Re: **ADDENDUM NO. 1**

NCDOT Division 10 Office Security Upgrades in Albemarle, NC
SCO ID#: **16-15785-01A**
ADW Job no.: 16020

**NCDOT
 DIVISION OF
 HIGHWAYS,
 DIVISION 10
 OFFICE
 SECURITY
 UPGRADES**

A101

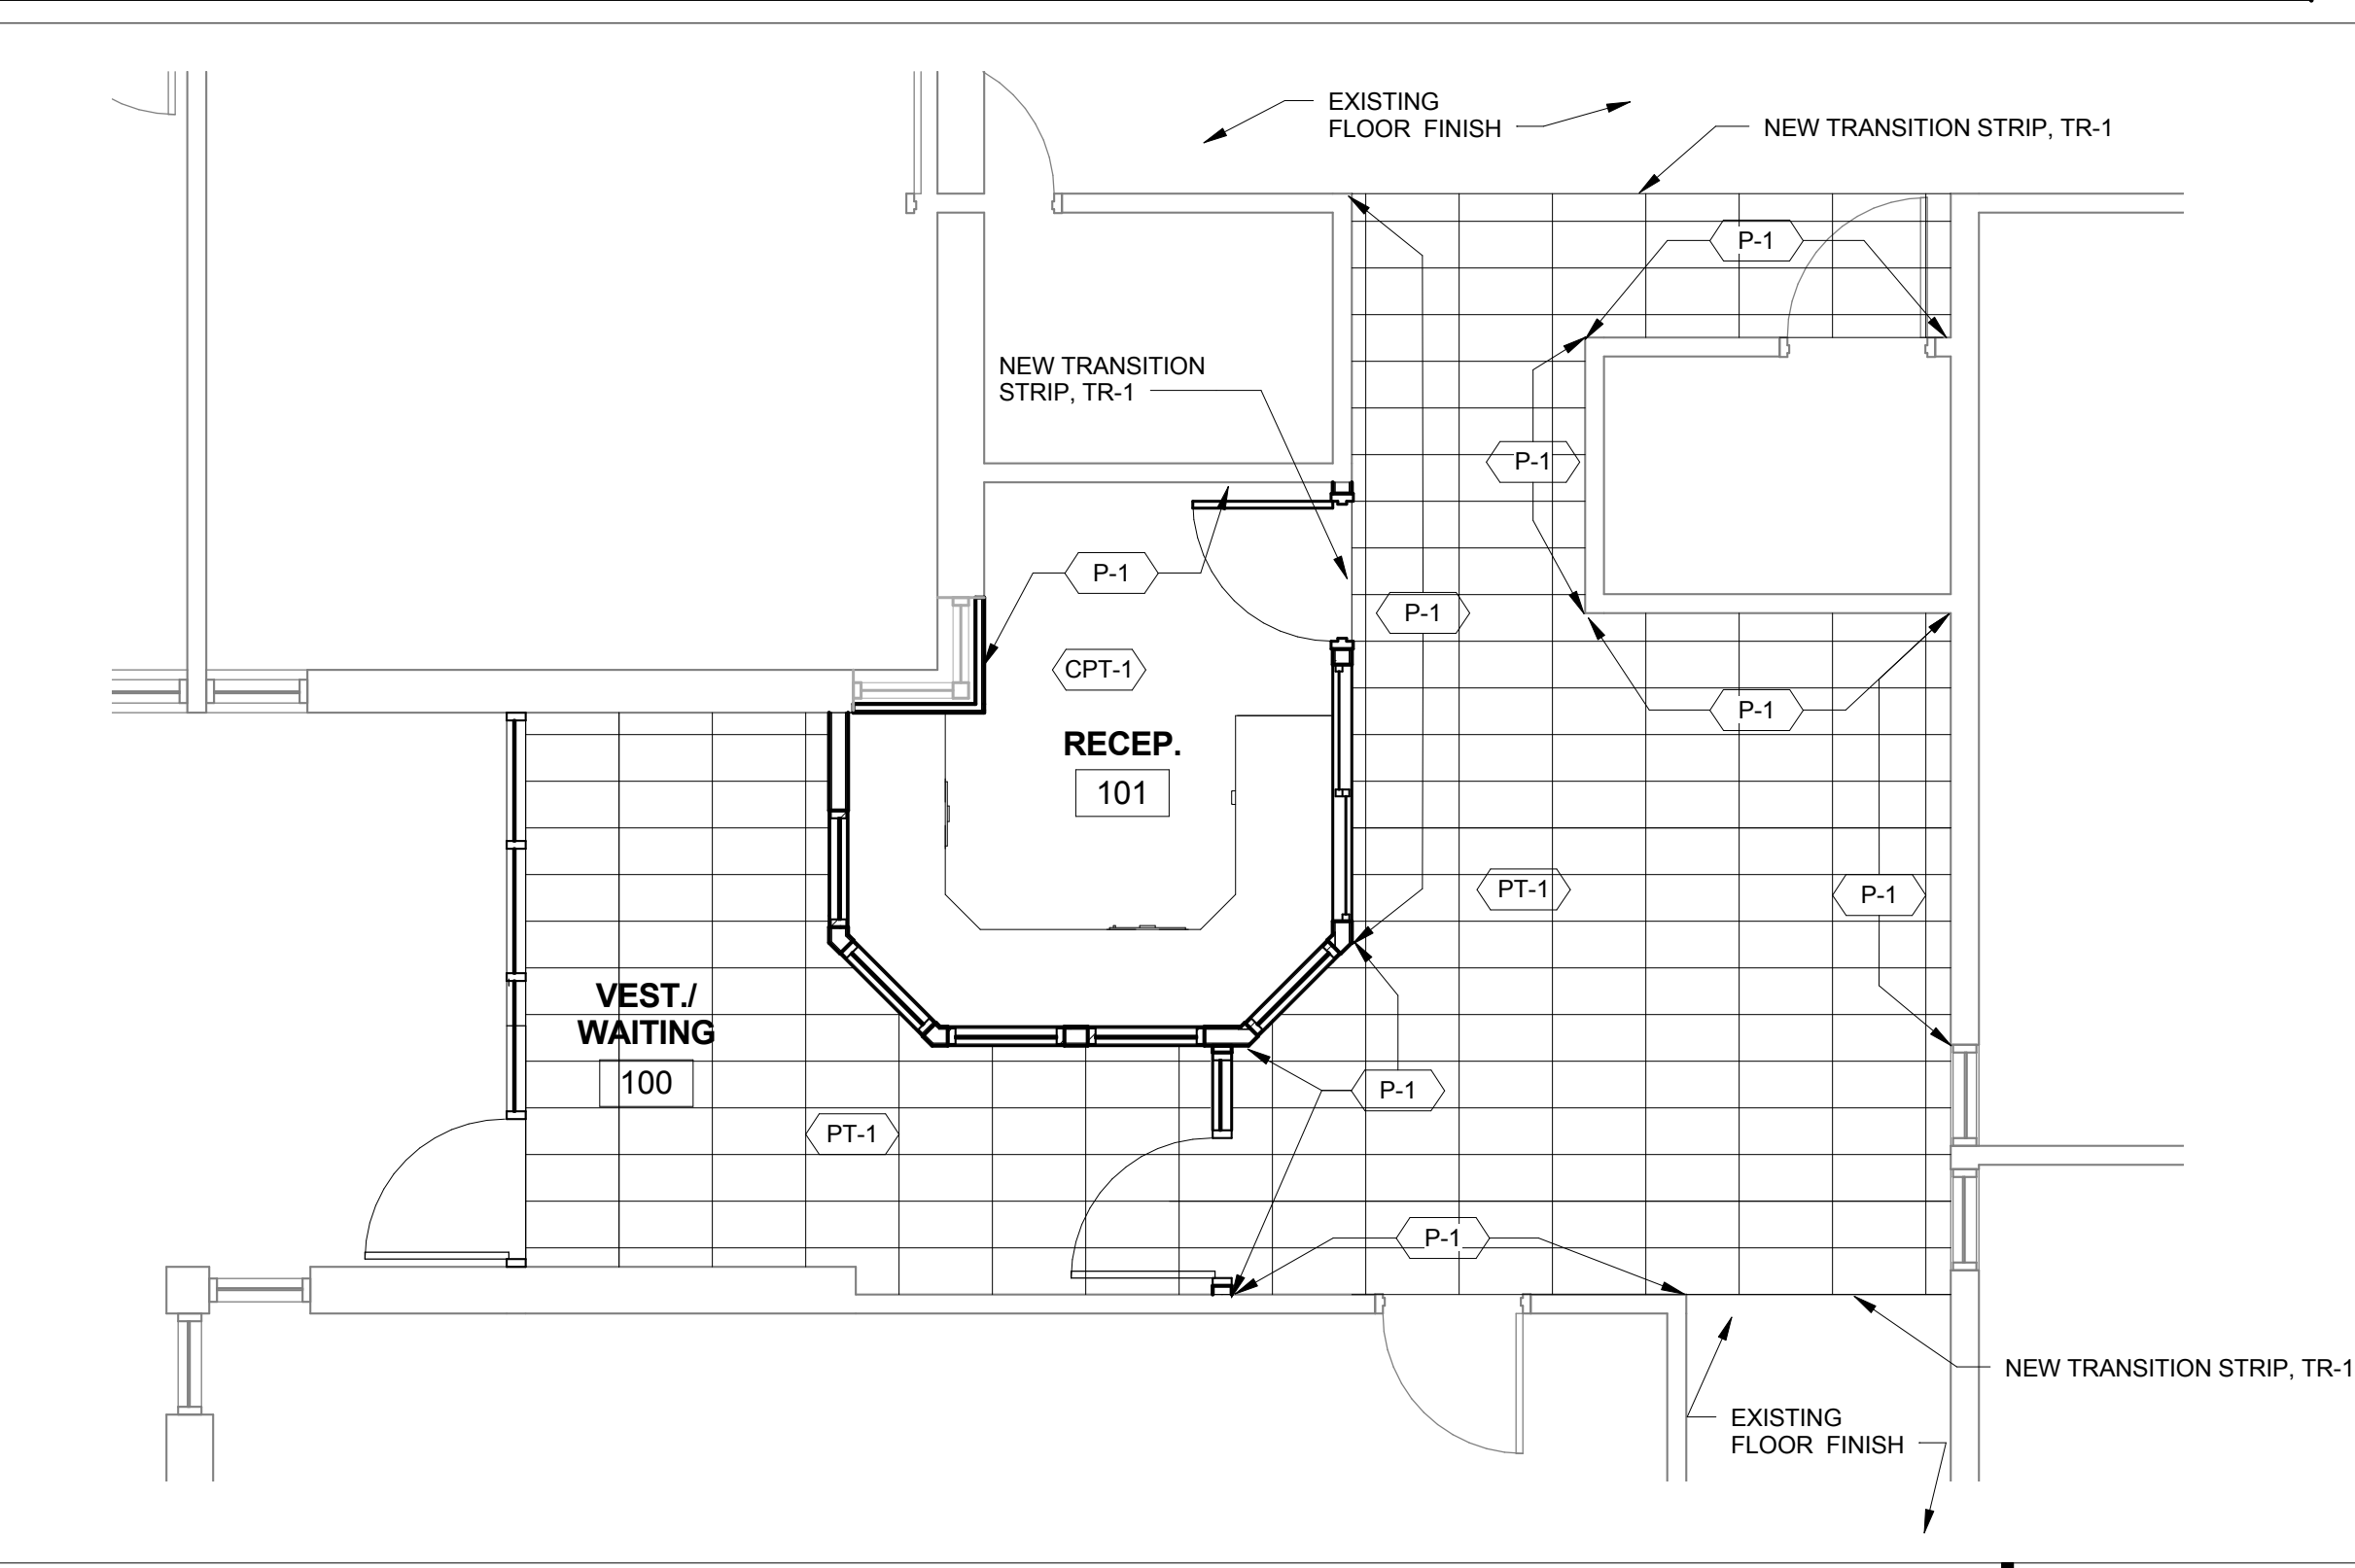
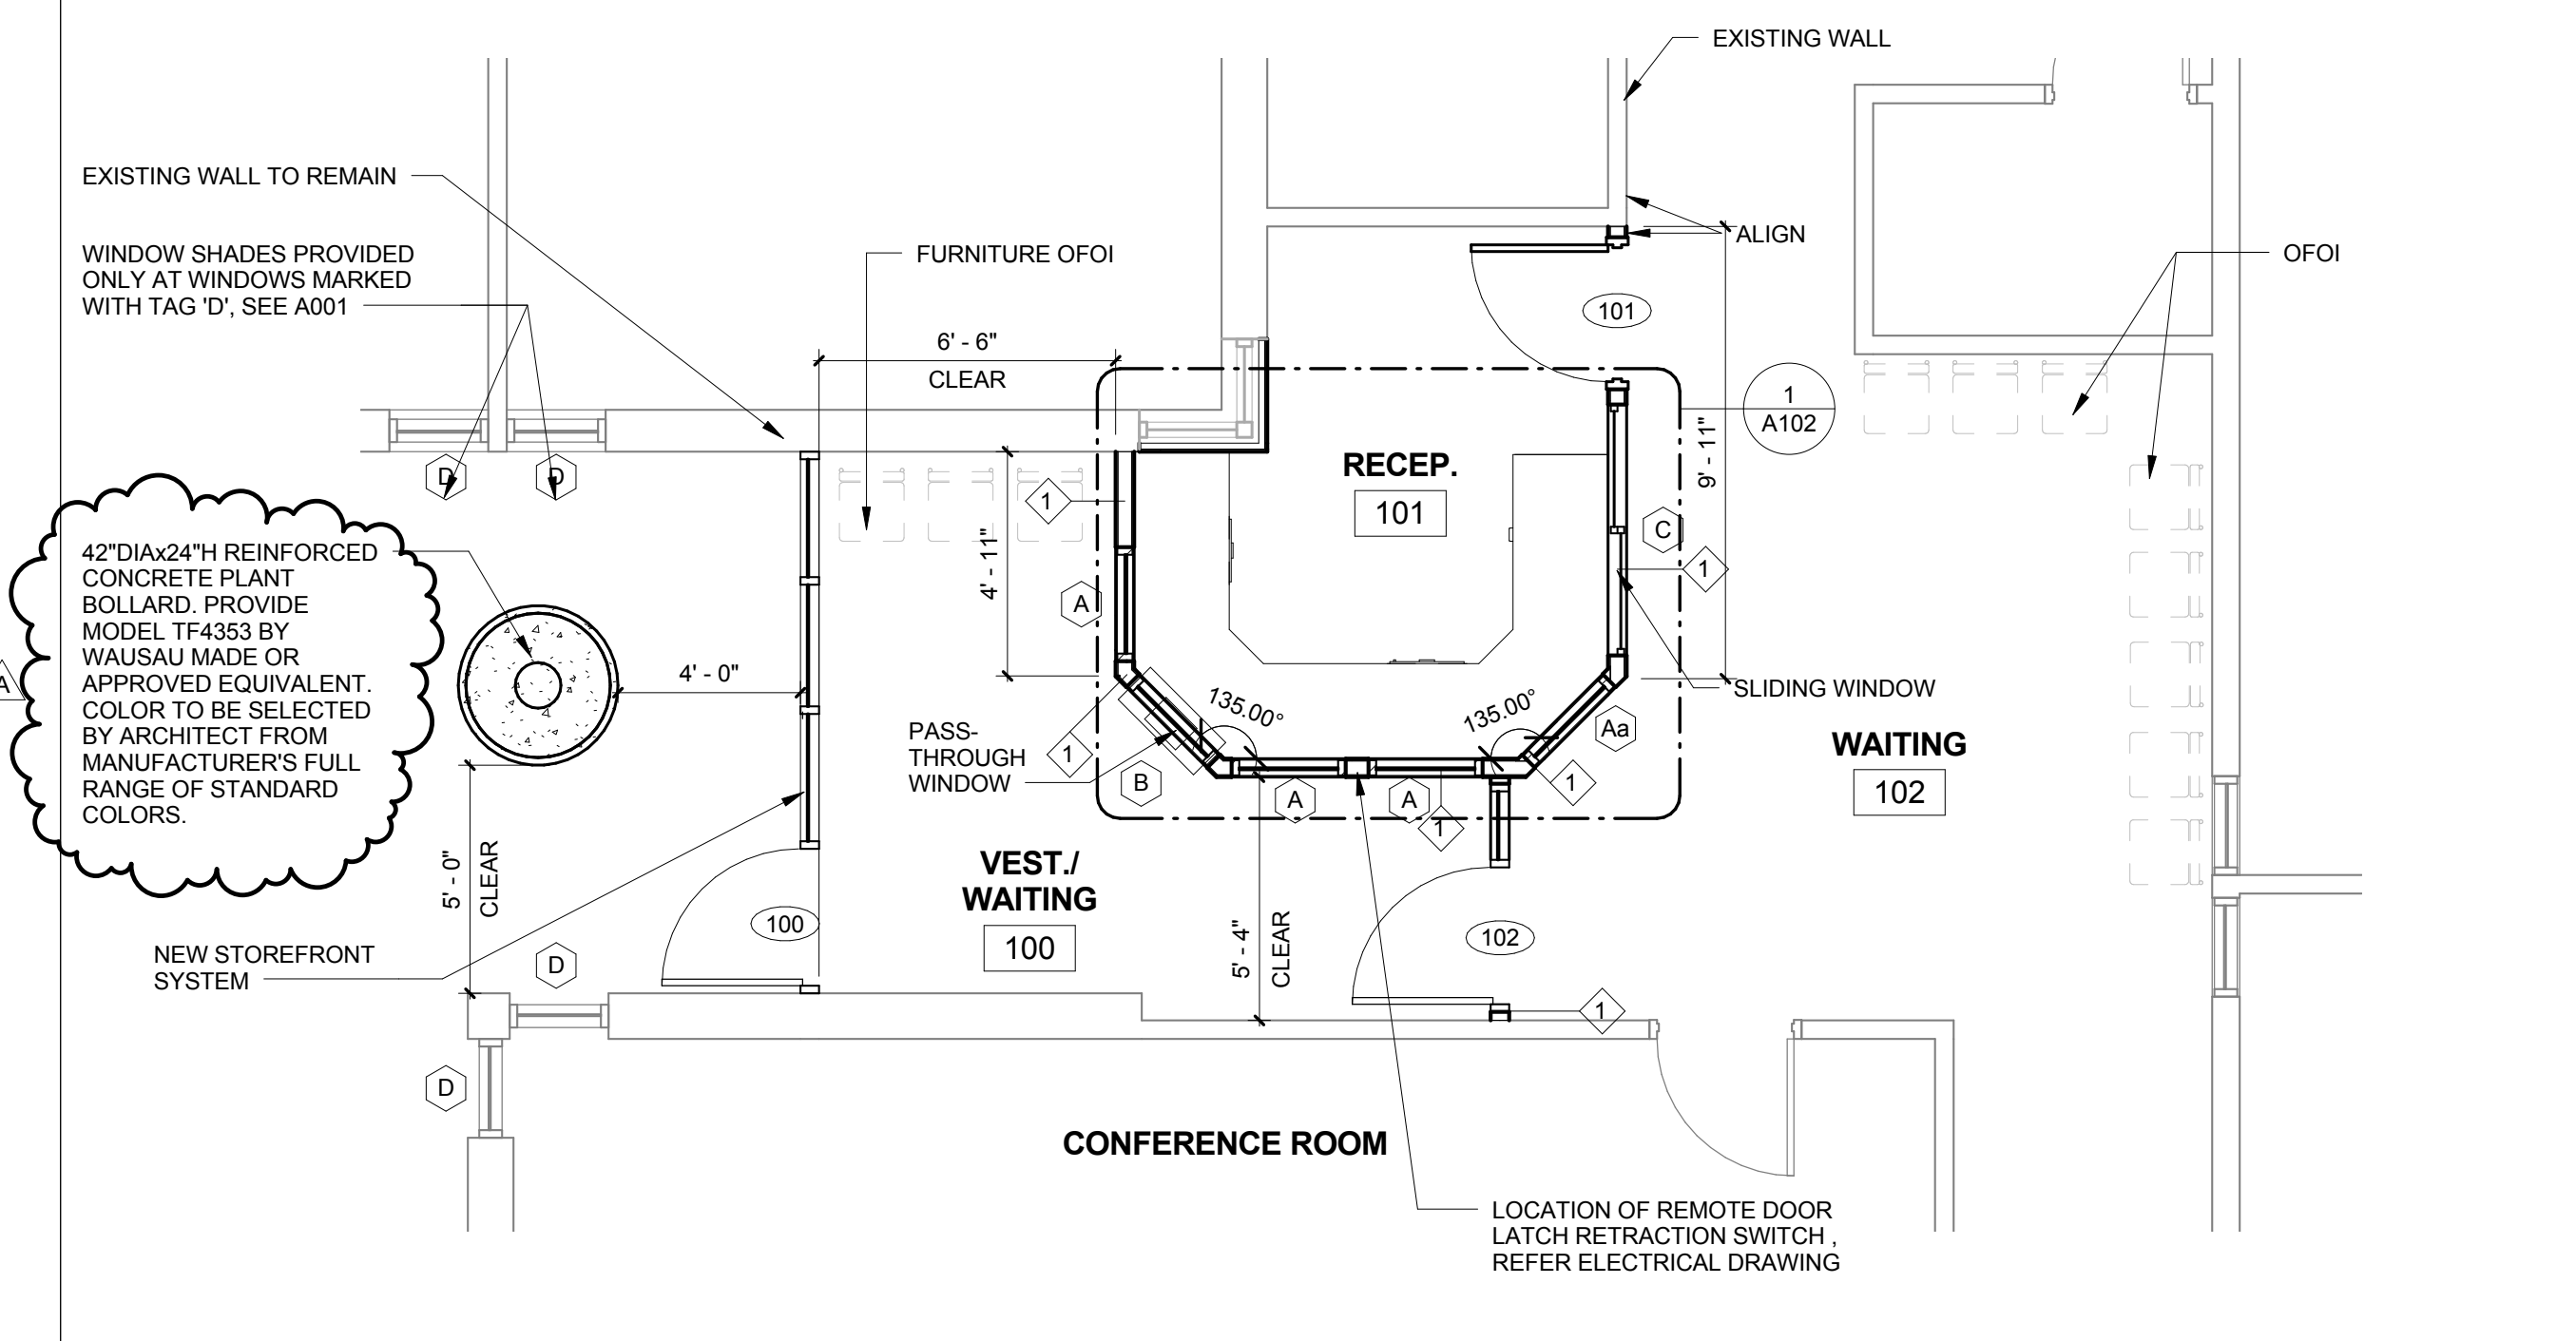
8. Attached are revised pdf files for sheets A101 and A102.
9. A101 – refer to additional information regarding site bollard.
10. A102 – refer to clarification on doors and windows.
